CITY OF ALBUQUERQUE

RE: TORRENTINO SUBDIVISION (L-9/D38)
Engineers Certification for Release of Financial Guaranty
Engineers Stamp dated 10/21/2005
Engineers Certification dated 09/16/2005

Re: Torrentino Subdivision Drainage Report
Engineer's Stamp dated 11-29-04 (L9/D38)

Re: Torrentino Subdivision Drainage Report
Engineer's Stamp dated 10-21-04 (L9/D38)

GRADING & DRAINAGE PLAN

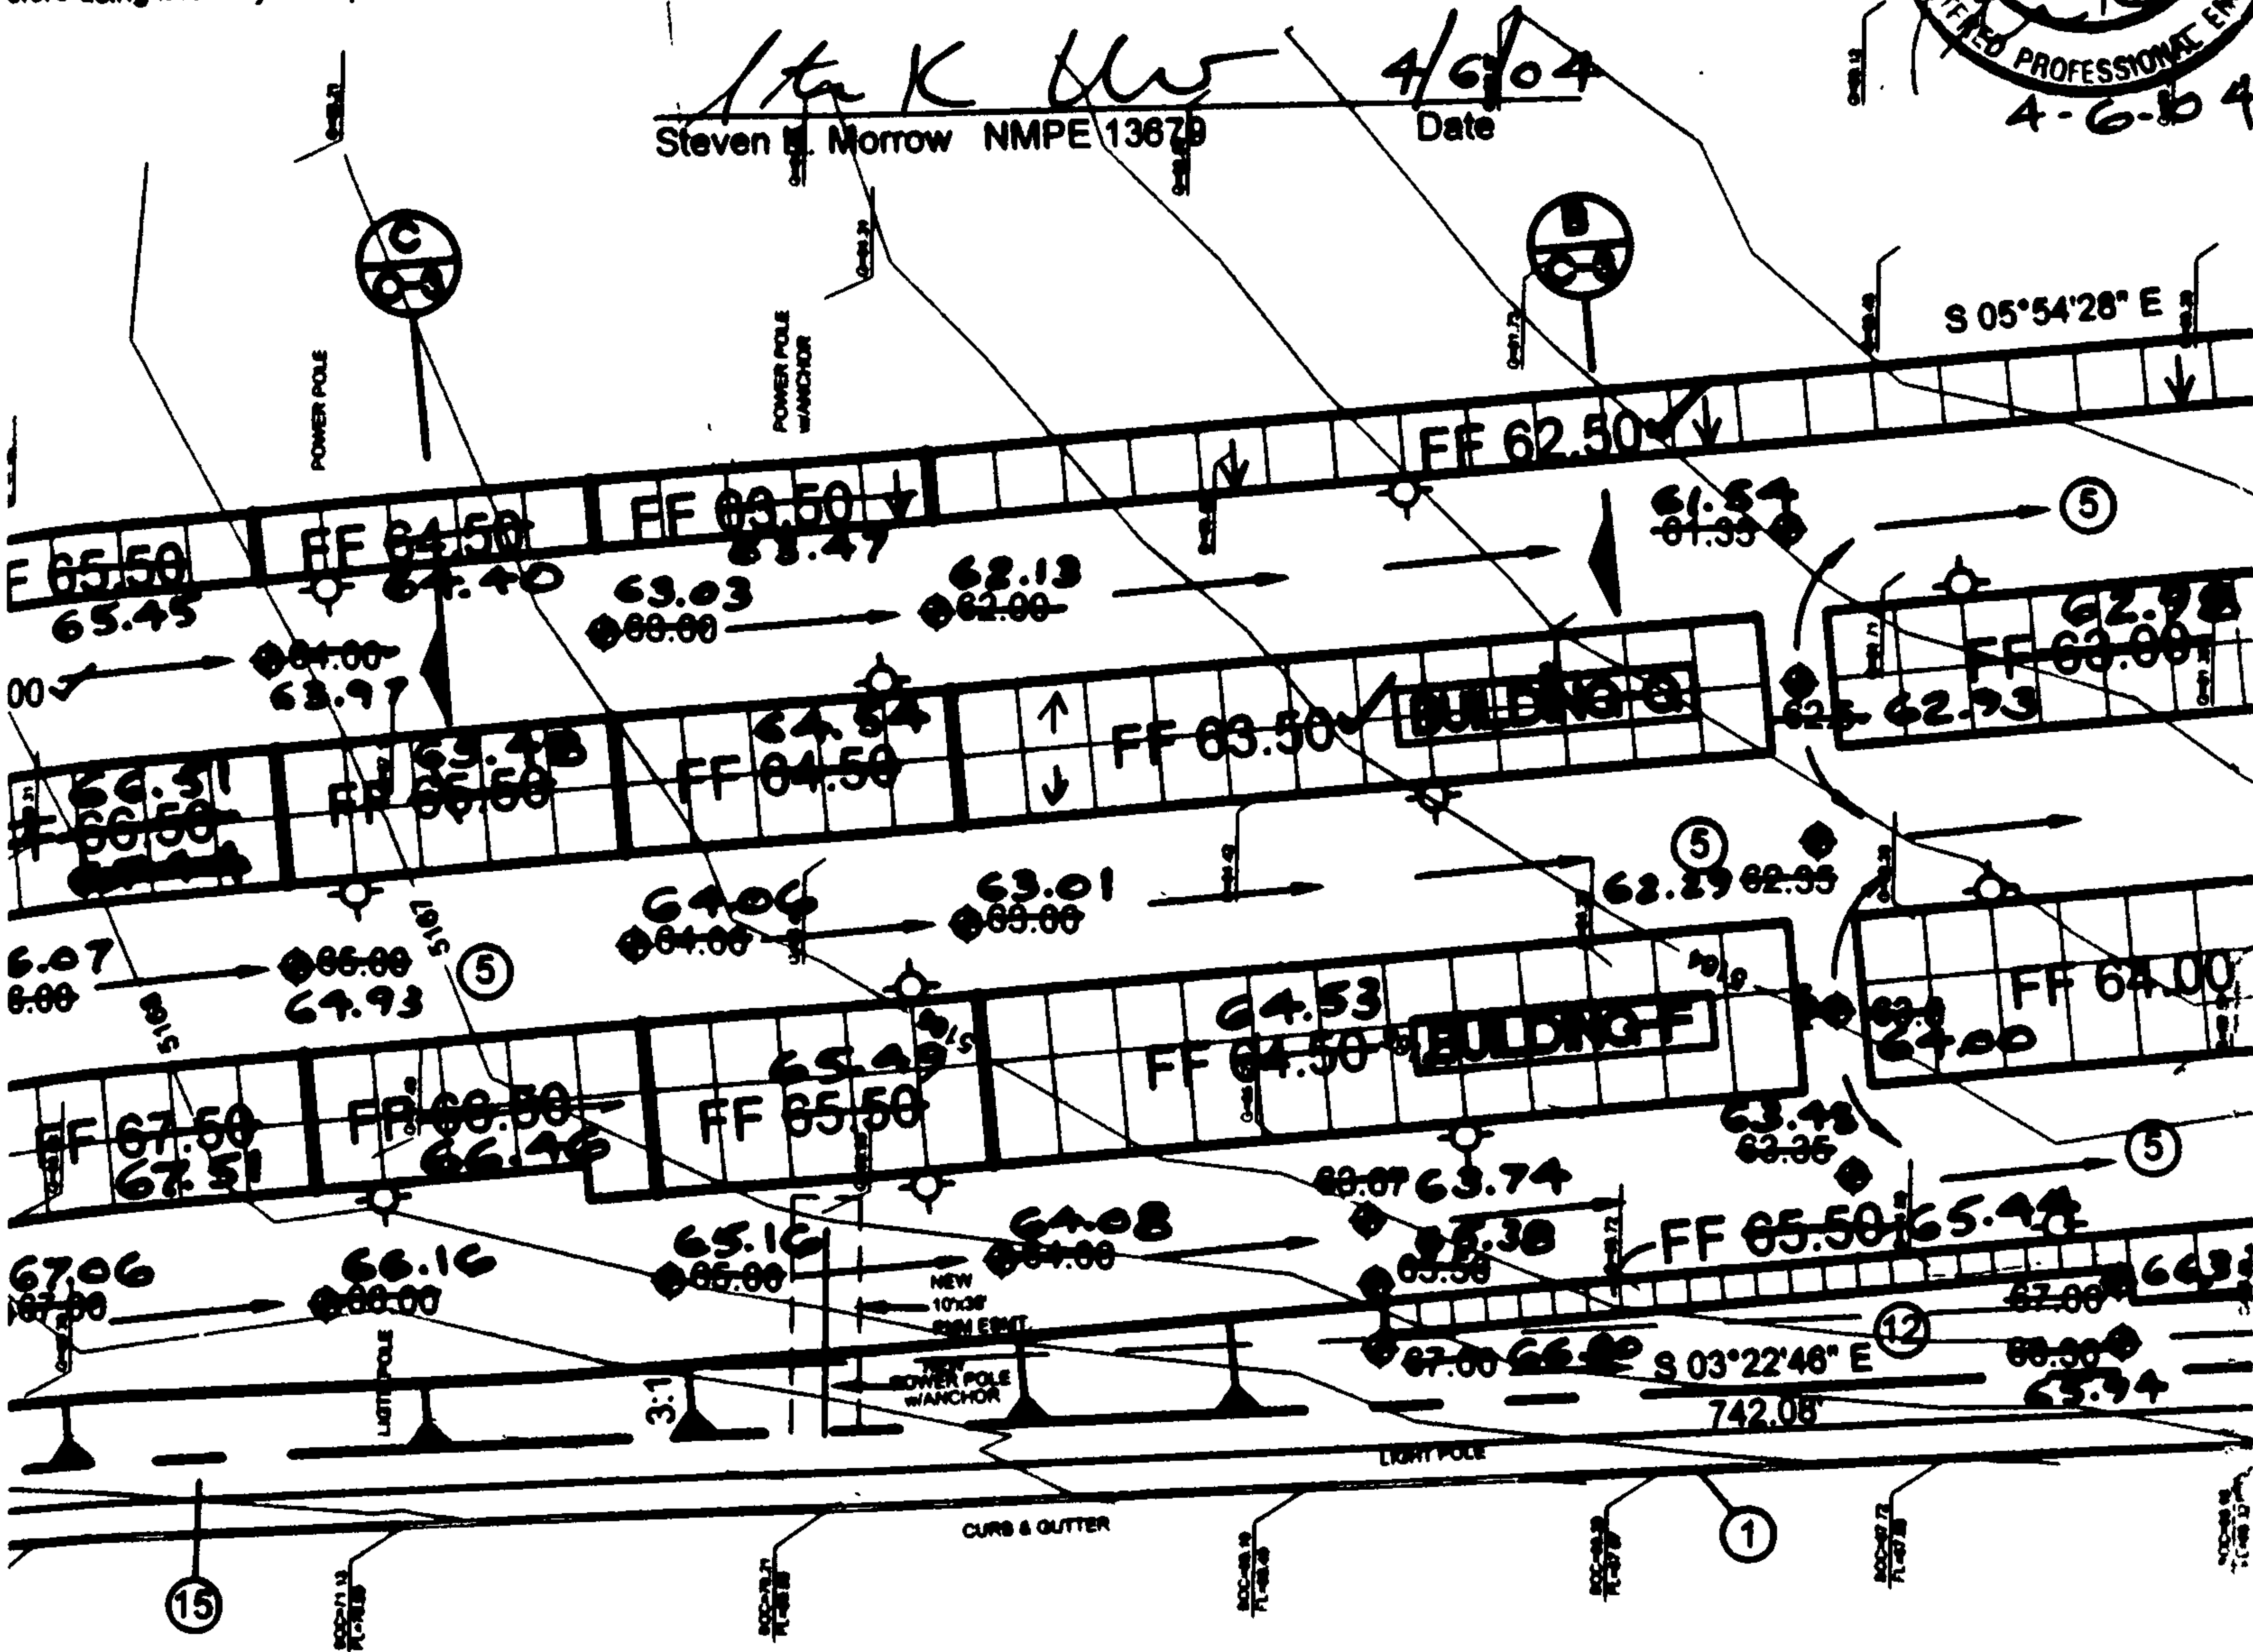
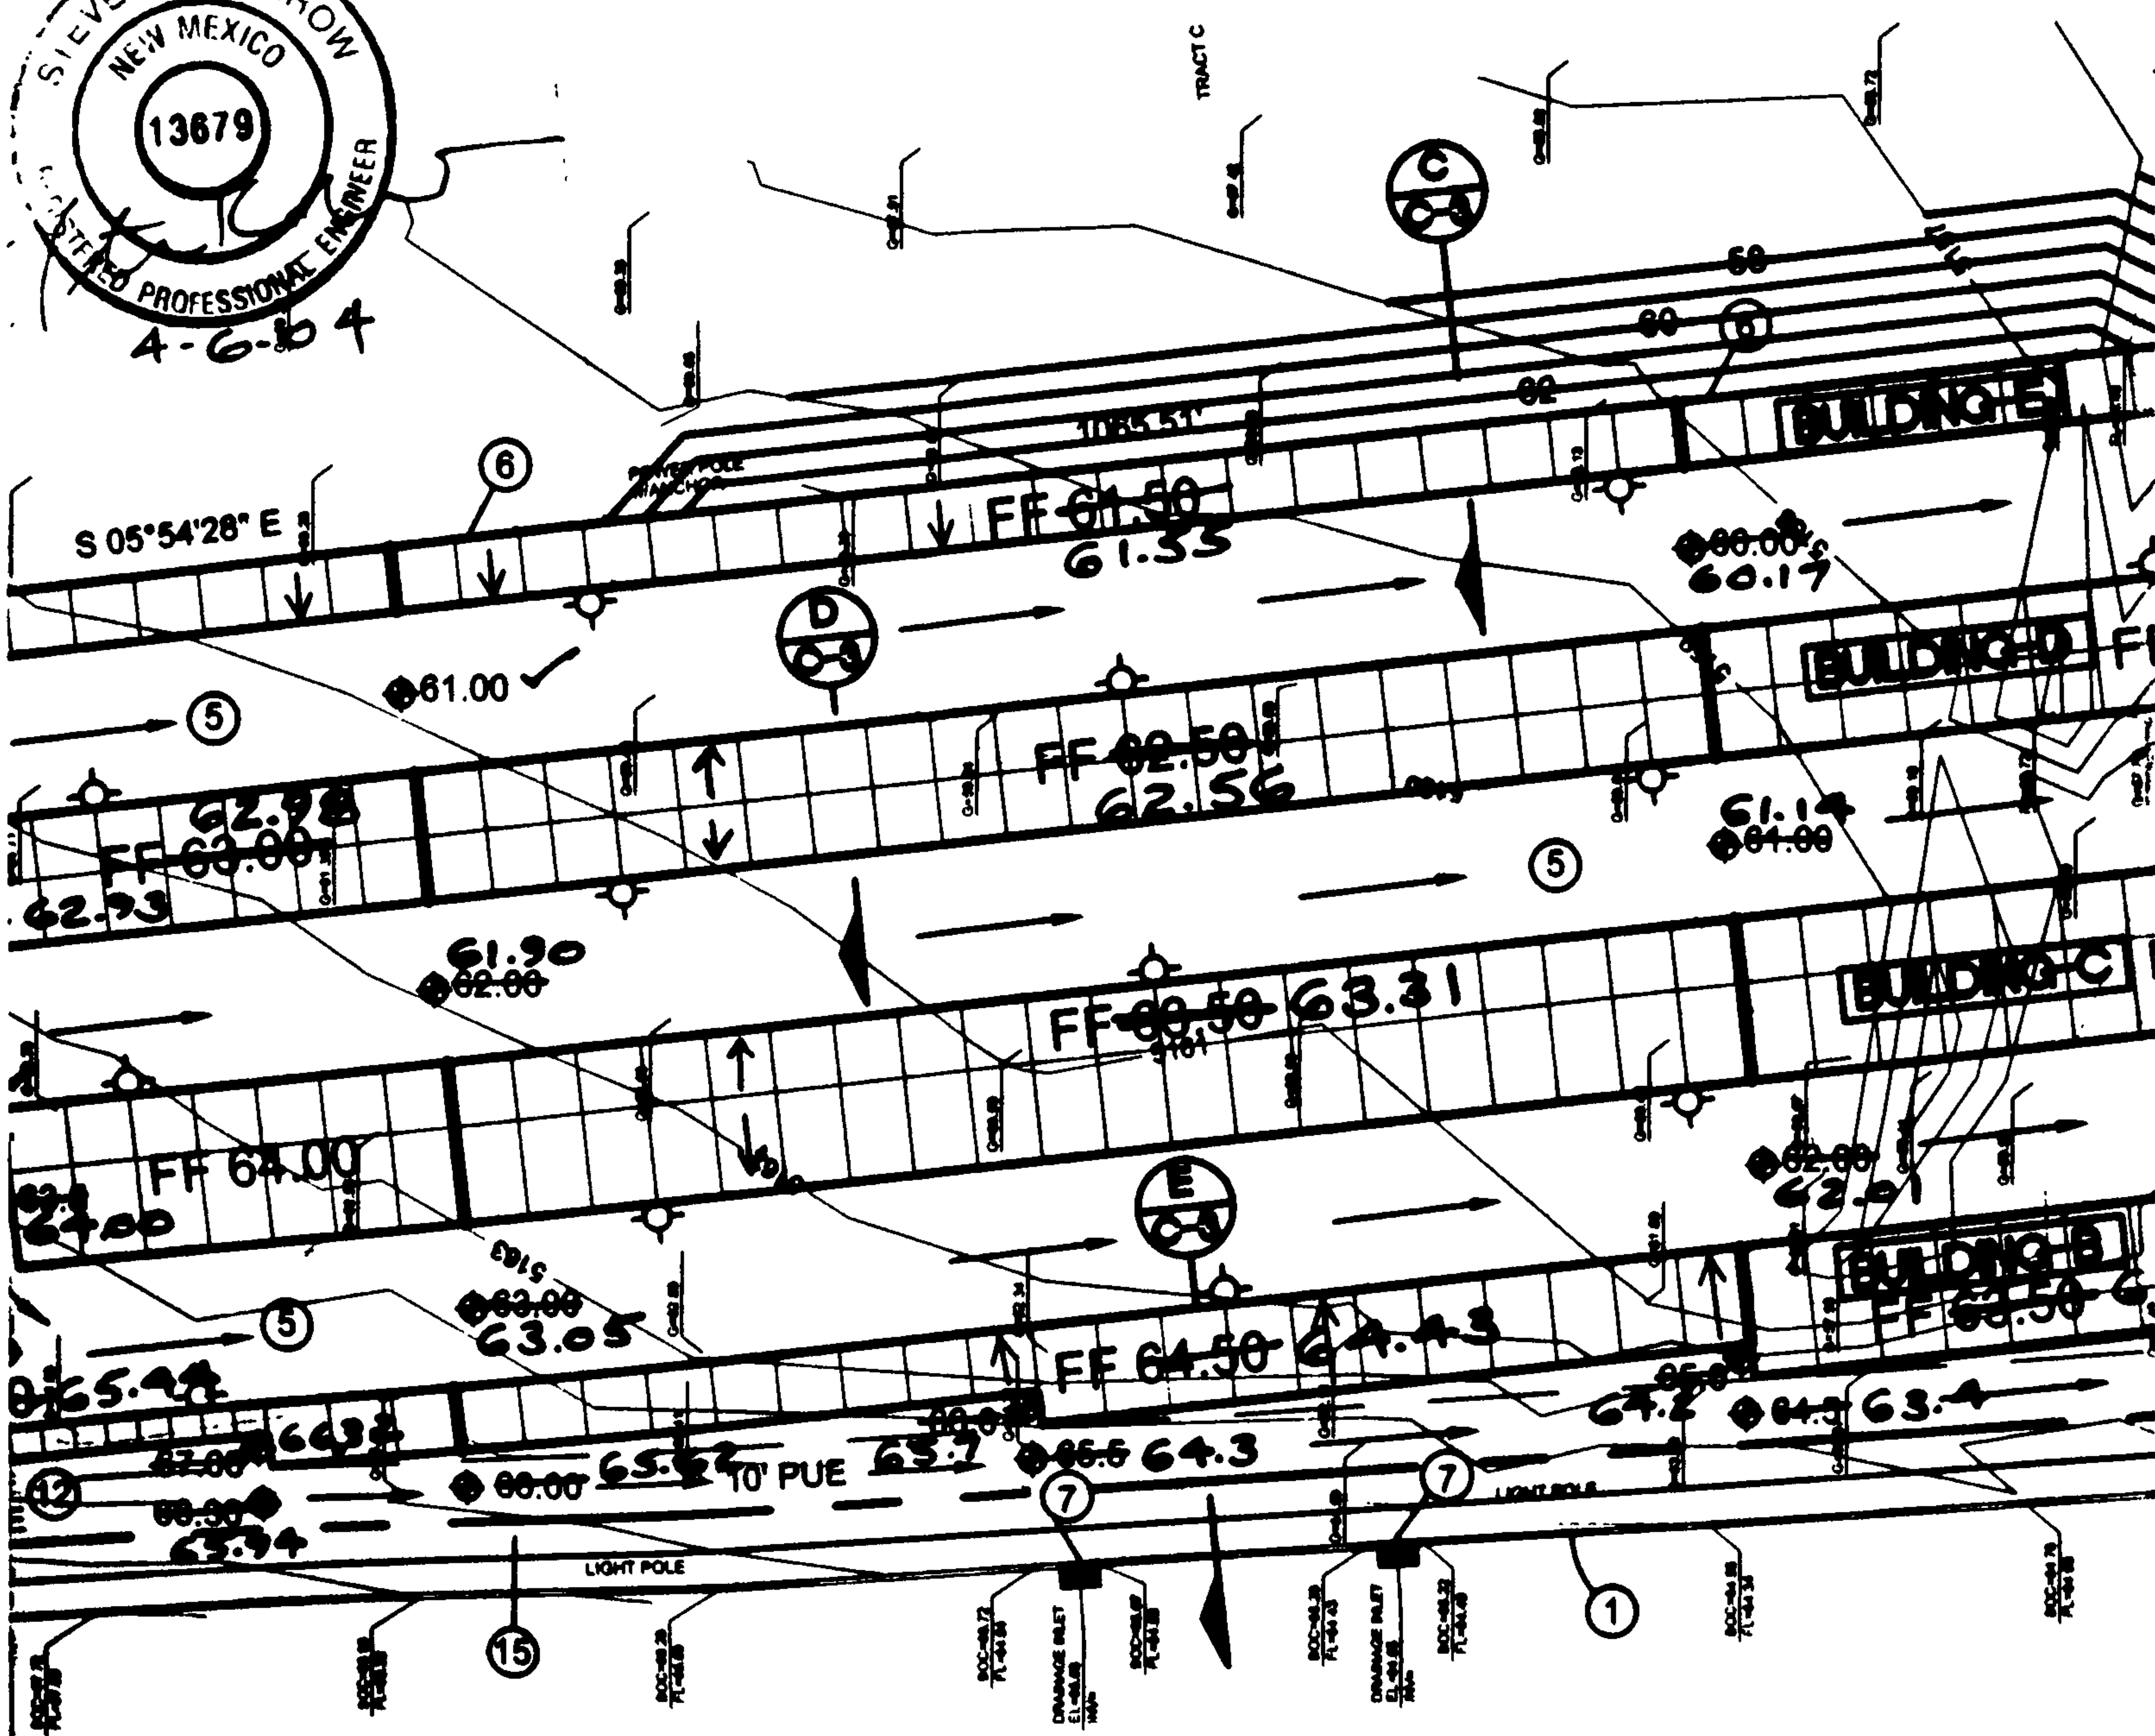
1. The ^{11/29/04}~~Approved~~ Grading and Drainage Plan has an Engineer Stamp date of ~~12/09/2003~~ not 10/21/2005?? as indicated in your submittal. (see attached copy of G/D Report approval letter).
